PLANNED MODIFICATIONS TO PERMIT TESTING TO BE CONTINUED IN ACCORDANCE WITH 10 CFR 50 APPENDIX J.

MONTICELLO NUCLEAR GENERATING PLANT  
Docket No. 50-263 License No. DPR-22

Planned Modifications to Permit Testing  
To Be Conducted in Accordance with 10 CFR 50, Appendix J

Figure 1. Drywell Instrument Air Containment Penetration

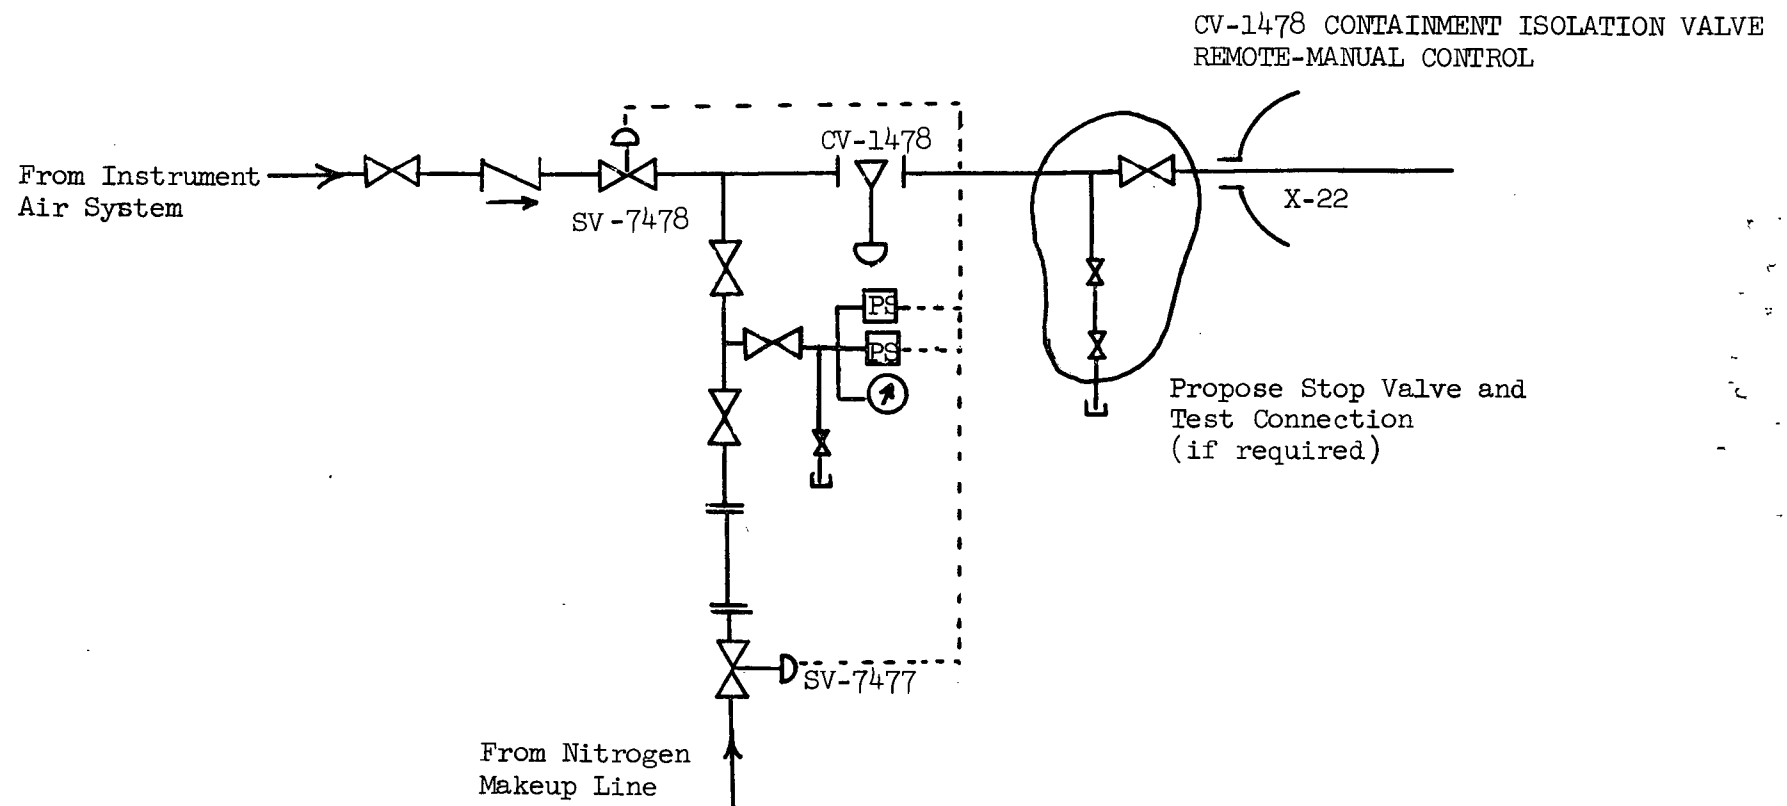
Further review of this penetration indicates that the control valve may be tested in the reverse direction utilizing sections of piping installed as part of a plant modification to supply nitrogen to the drywell instrument air header. Testing this valve in the reverse direction will yield a conservative leakage rate measurement.

If testing of this valve is found to be impractical using this method, a test connection and stop valve can be added to the instrument air line to permit Type C testing (Figure 1).

Figure 2. Cooling Water Supply and Return From Drywell  
Containment Penetrations

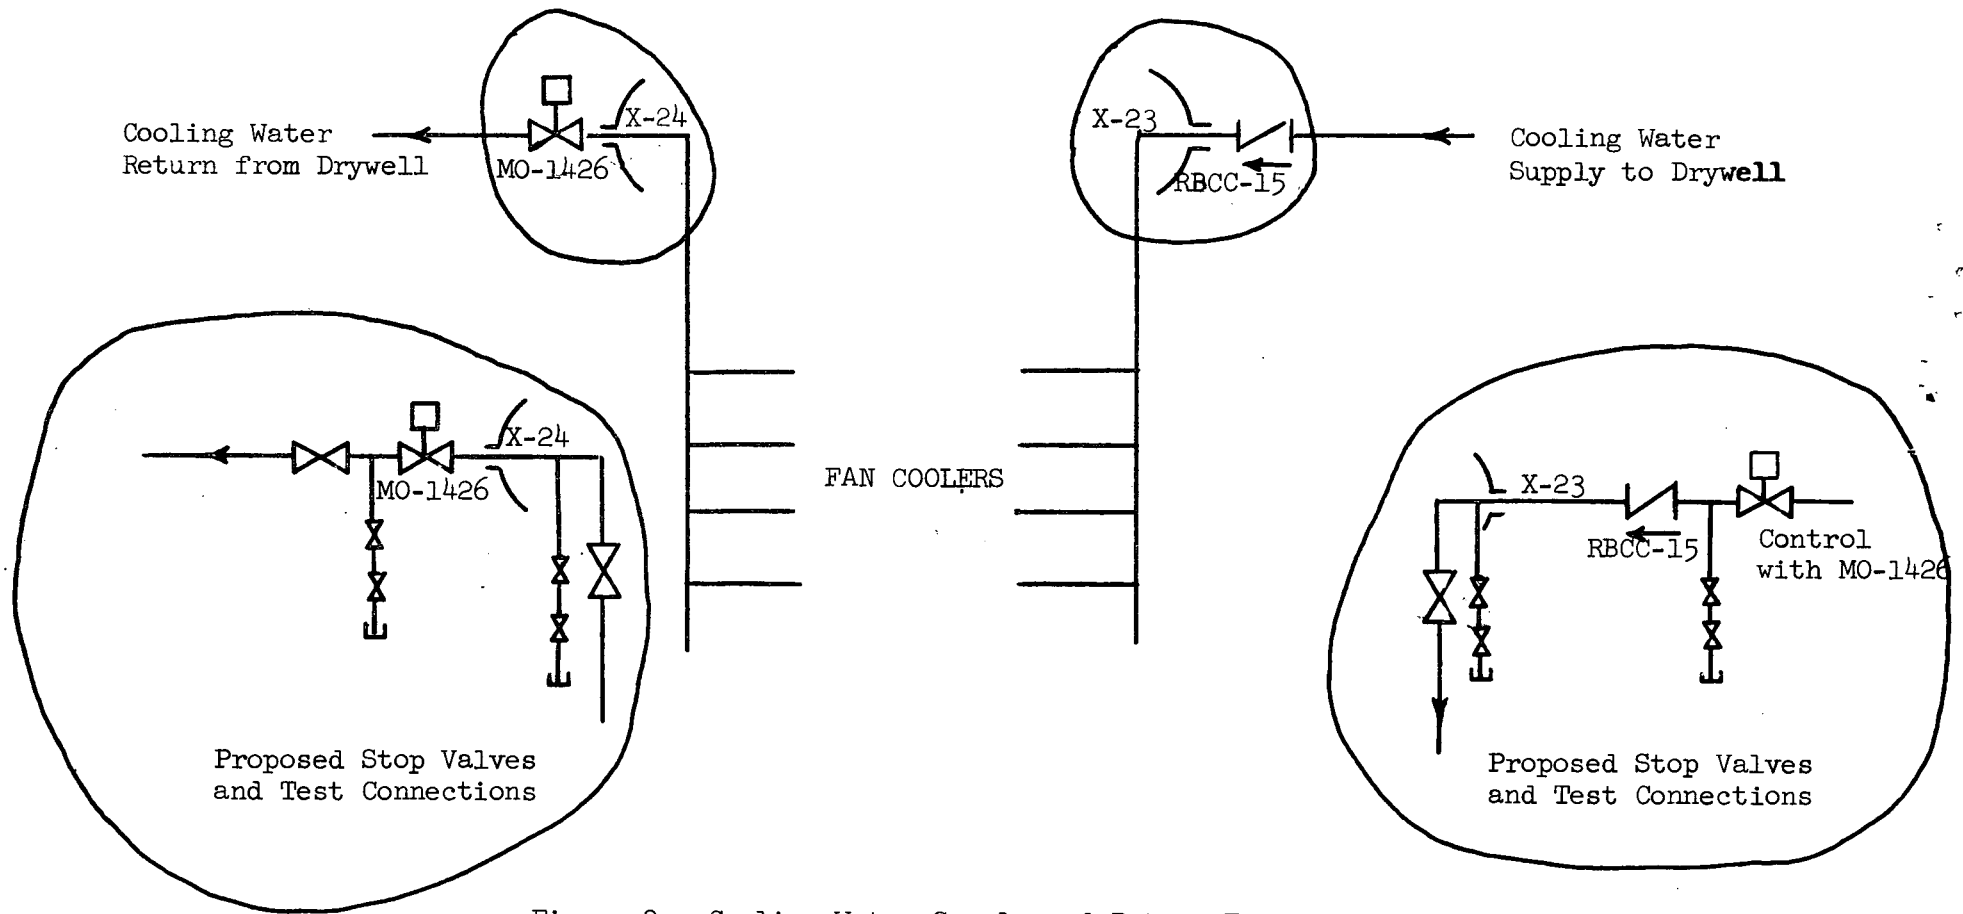
Test connections and stop valves can be added to the cooling water supply and return lines (Figure 2) to allow Type C tests.

Figure 3. TIP and TIP Purge Containment Penetrations

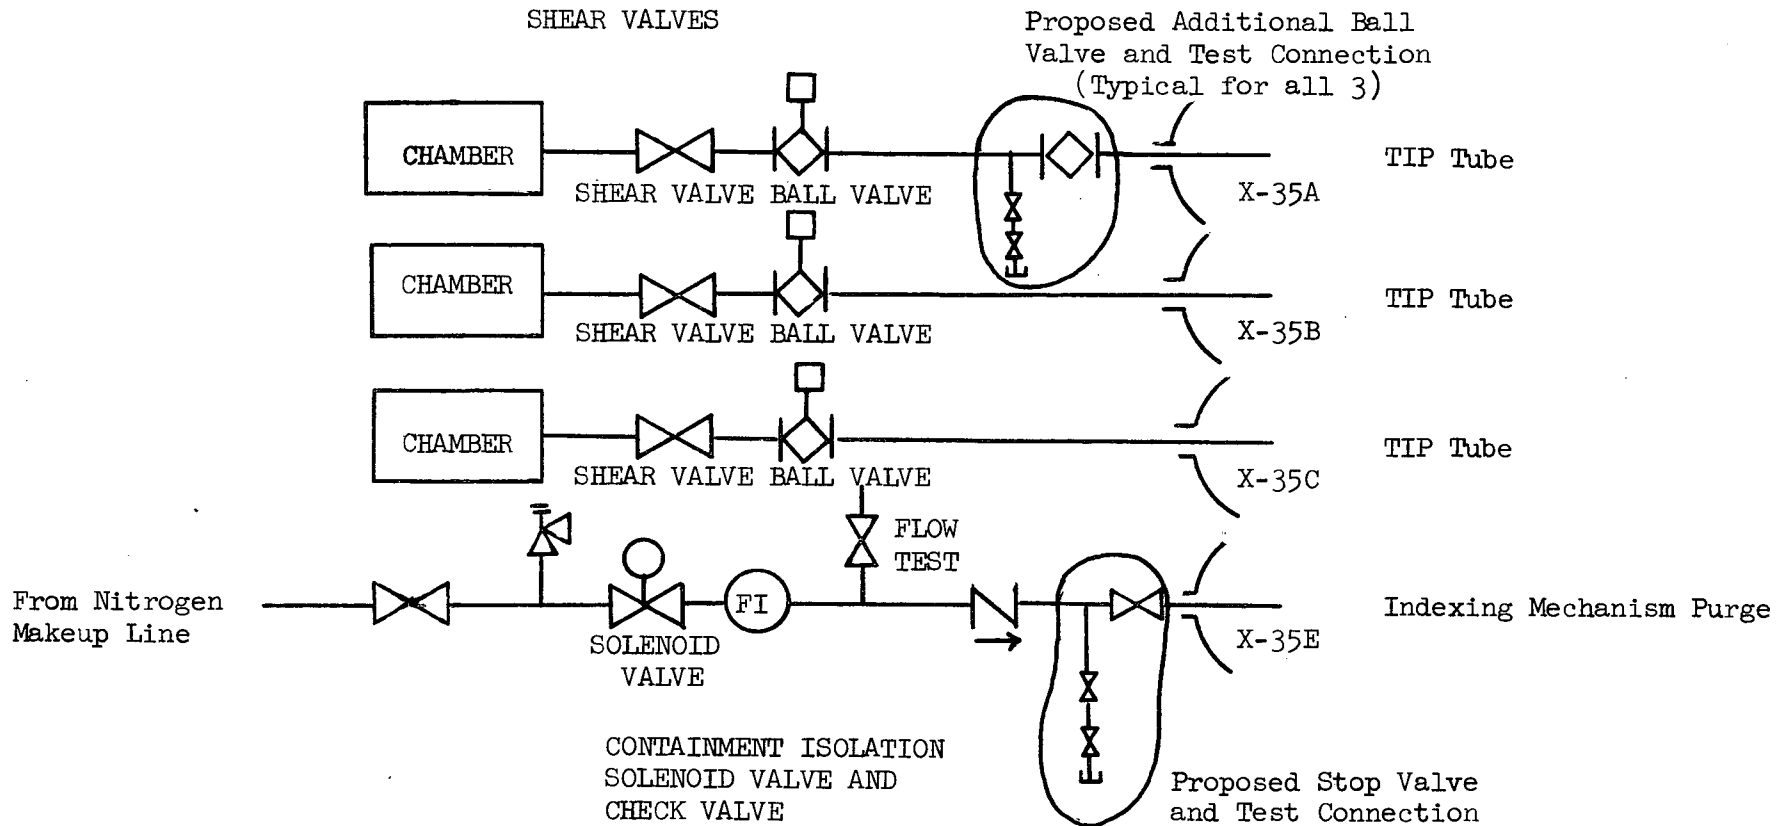
An additional ball valve and test connection can be installed in each TIP line to permit leakage testing of the ball valve. An additional stop valve and test connection can be installed in the nitrogen purge supply line to permit leakage testing of the check valve (Figure 3).

Figure 4. CRD Hydraulic Return Containment Penetration

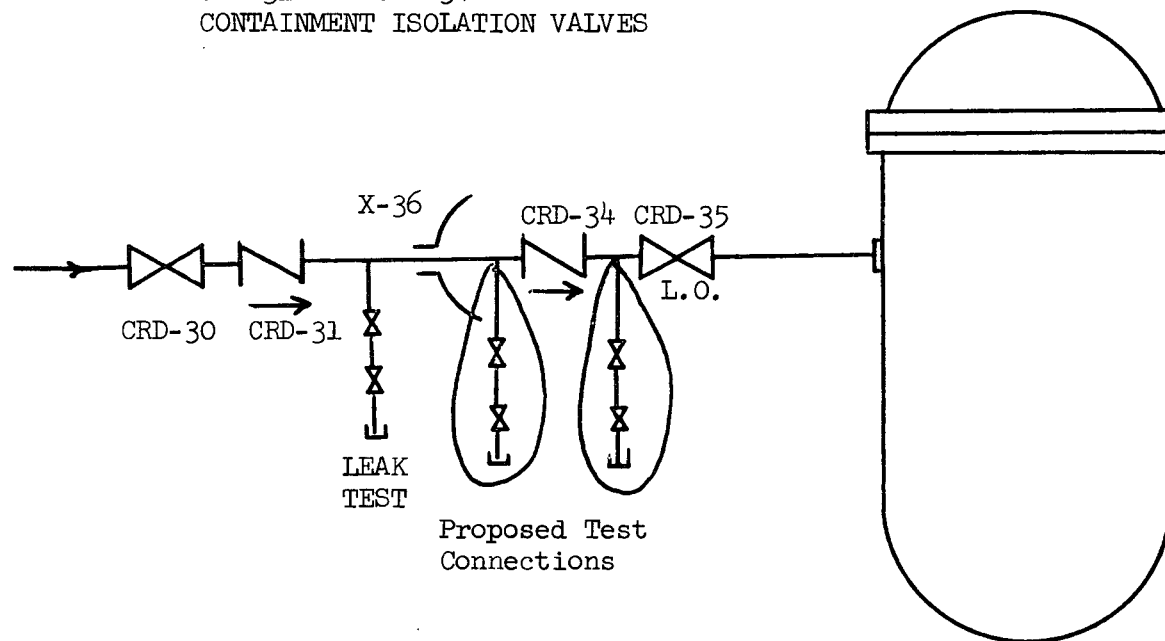
Additional test connections can be added on each side of the inboard check valve to allow Type C testing of this valve. Only the outboard check valve is now testable (Figure 4).

Figure 5. SBLC Containment Penetration

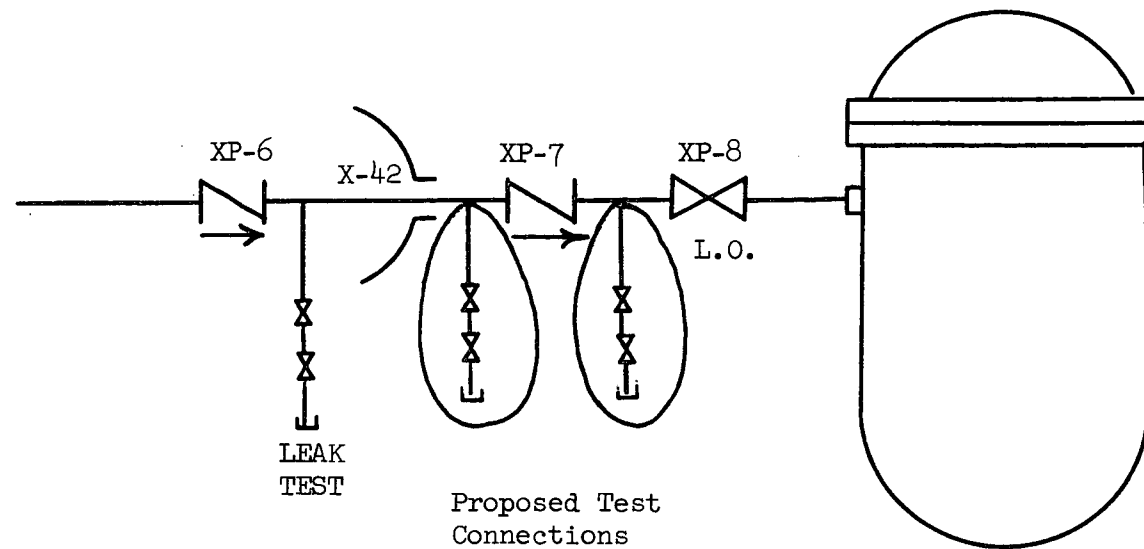
Additional test connections can be added on each side of the inboard check valve to allow Type C testing of this valve. Only the outboard check valve is now testable (Figure 5).

Figure 6. HPCI Turbine Exhaust Containment Penetration

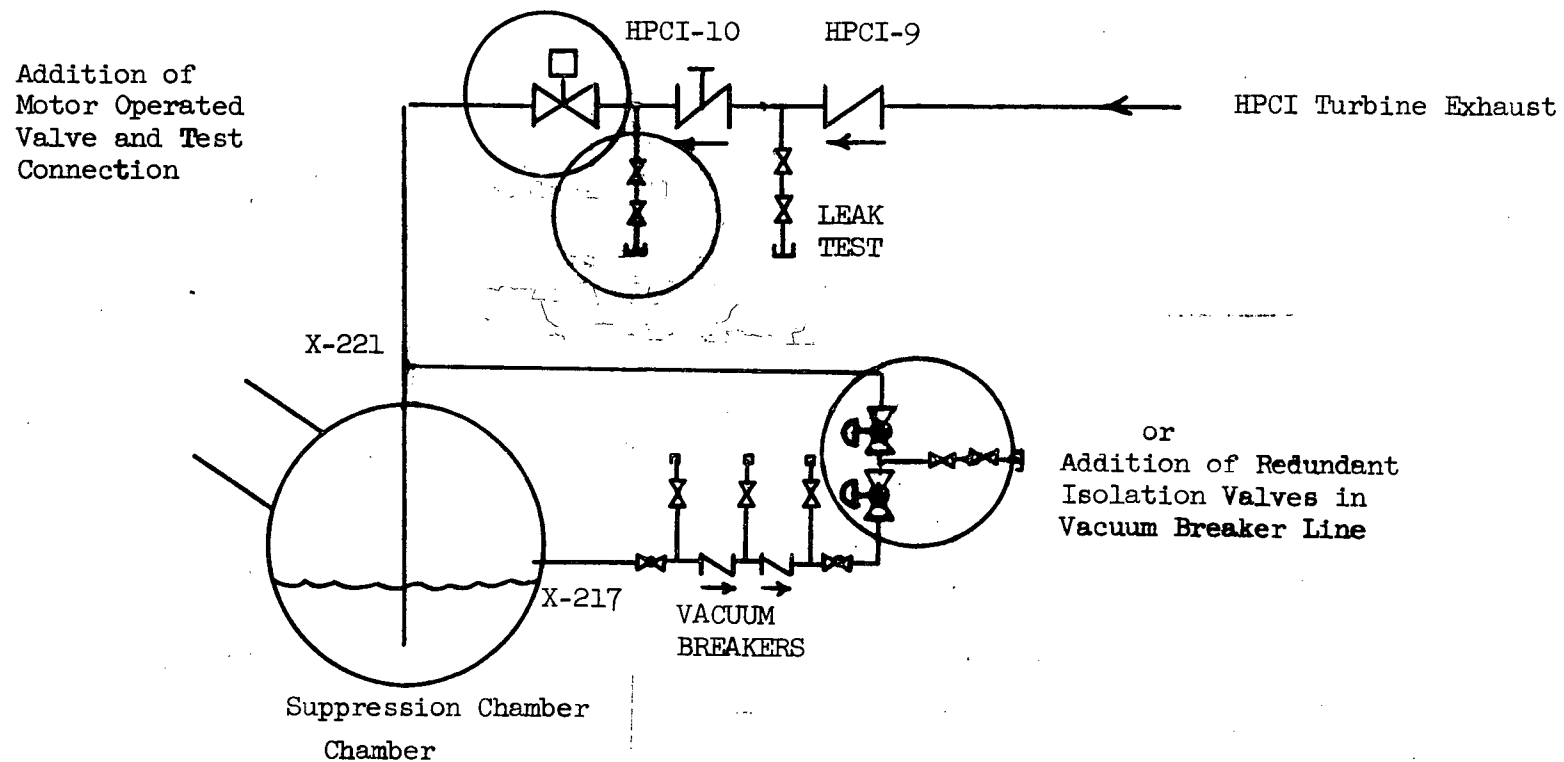
The check valves serving as containment isolation for the HPCI turbine steam exhaust line have a history of excessive leakage. Two check valves are installed, one of which is subjected to periodic Type C tests.

Two different modifications are being considered to resolve this problem (Figure 6). The first modification involves installing an additional motor operated valve in the turbine exhaust line. This valve would be subjected to periodic Type C tests and would be considered the containment

isolation valve in this line. The second modification involves installing redundant isolation valves in the vacuum breaker line. These valves would receive Group 4 isolation signals and would preclude the entry of the post LOCA torus atmosphere into this line. A water seal would then be provided by the water in the suppression pool.

Figure 7. RCIC Turbine Exhaust Containment Penetration

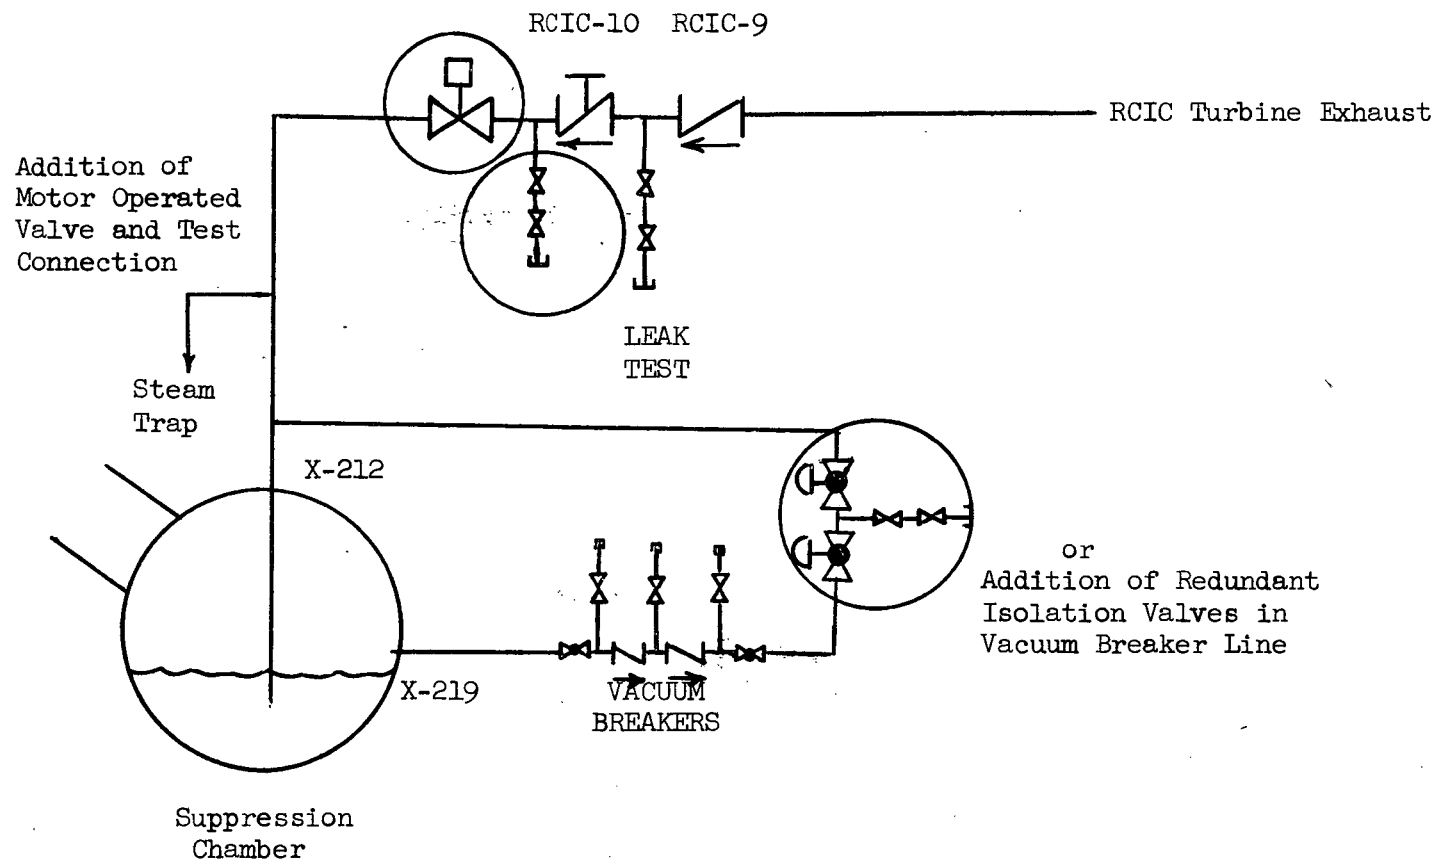
The check valves serving as containment isolation for the RCIC turbine steam exhaust line have a history of excessive leakage. As in the case of the HPCI system, two check valves are installed. One of these valves satisfies the minimum requirements for containment isolation and is subjected to periodic Type C tests. The other valve (the inboard check valve) cannot be tested in accordance with Appendix J.

Two different modifications are being considered to resolve the check valve leakage problems (Figure 7). These modifications are identical to those being considered for the HPCI system. The first modification involves installing an additional motor operated valve in the turbine exhaust line. The alternate modification involves installing redundant isolation valves in the vacuum breaker line. These valves would receive Group 5 isolation signals.

Figure 8. Demineralized Water Supply Containment Penetration

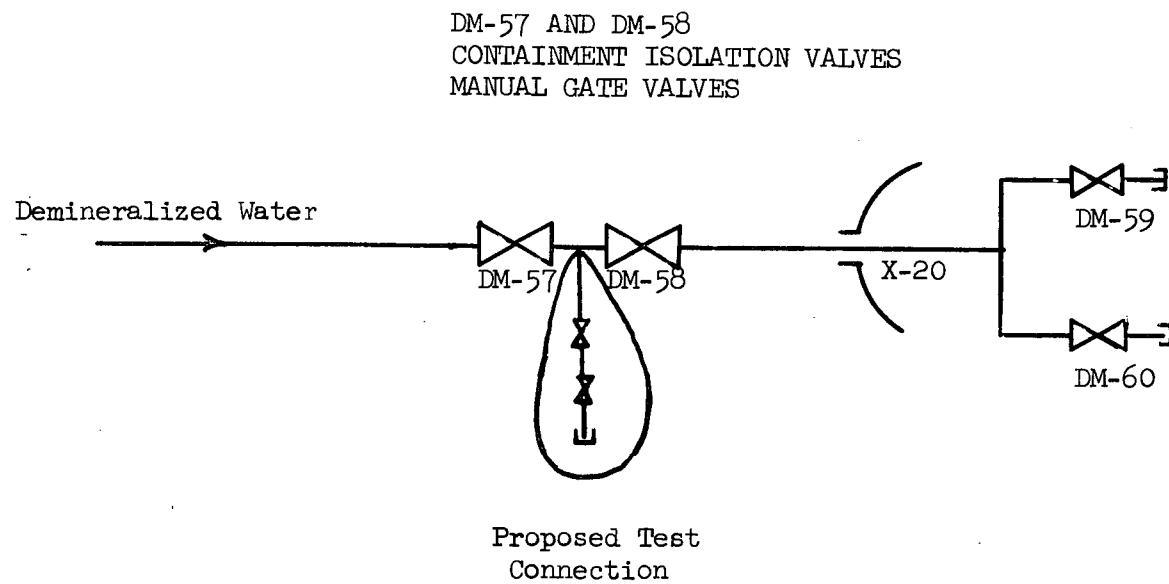
A test connection can be installed to permit Type C testing of the two manual valves in this line (Figure 8).

Figure 9. Service Air Supply Containment Penetration

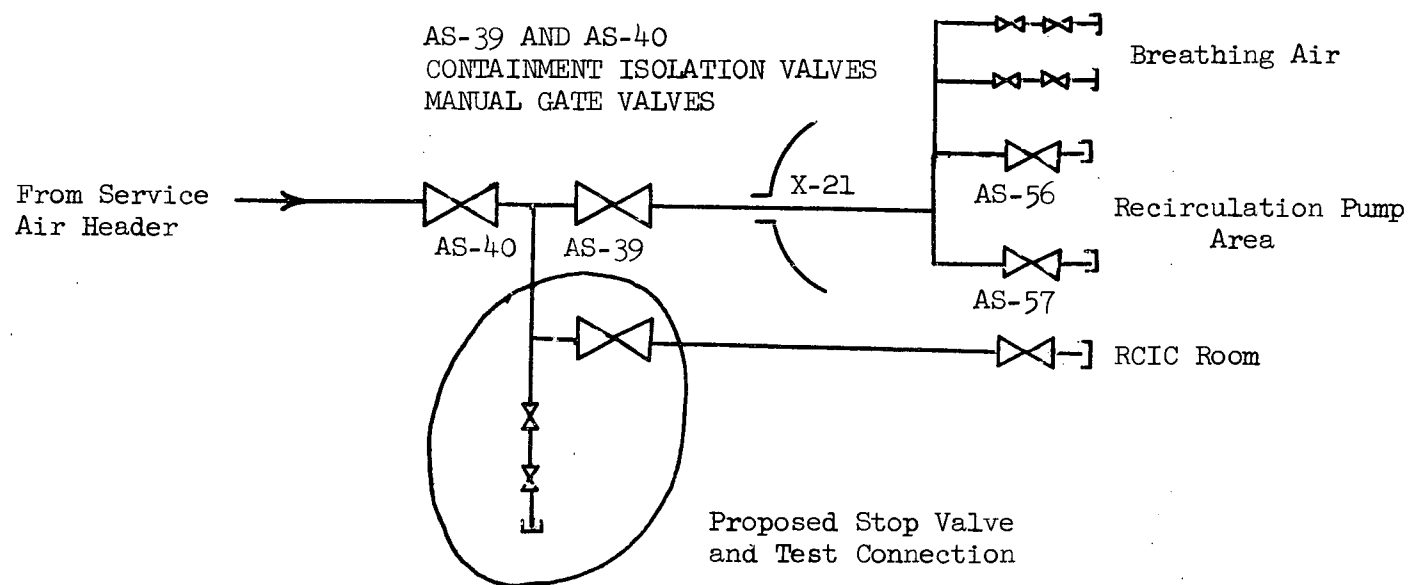
A test connection and additional stop valve can be installed to permit Type C testing of this penetration (Figure 9).

Figure 10. Torus Instrument Air Supply Containment Penetration

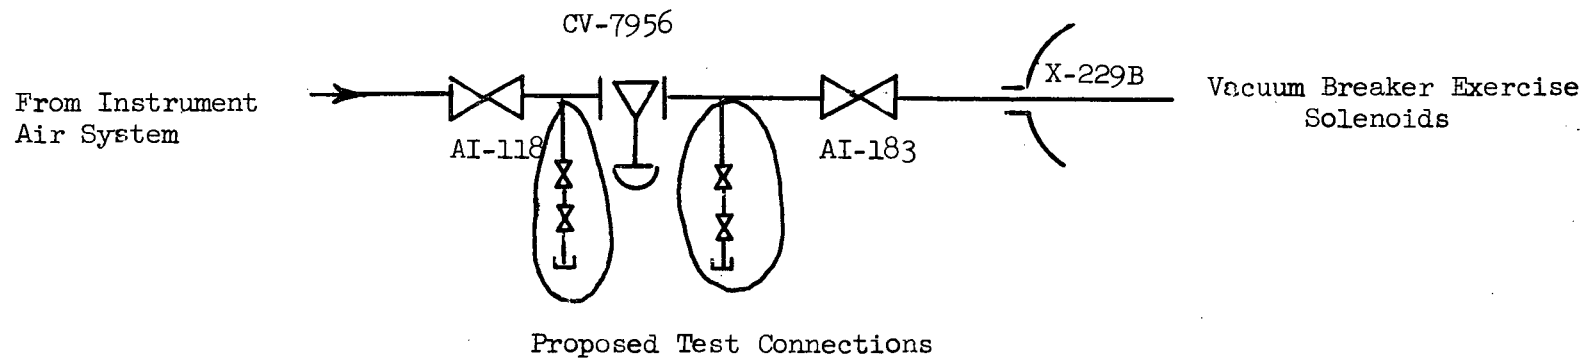
A plant modification was recently completed which added an instrument air supply line to the torus for vacuum breaker exercising (Figure 10). Test connections can be added to this line to permit Type C testing of the control valve.
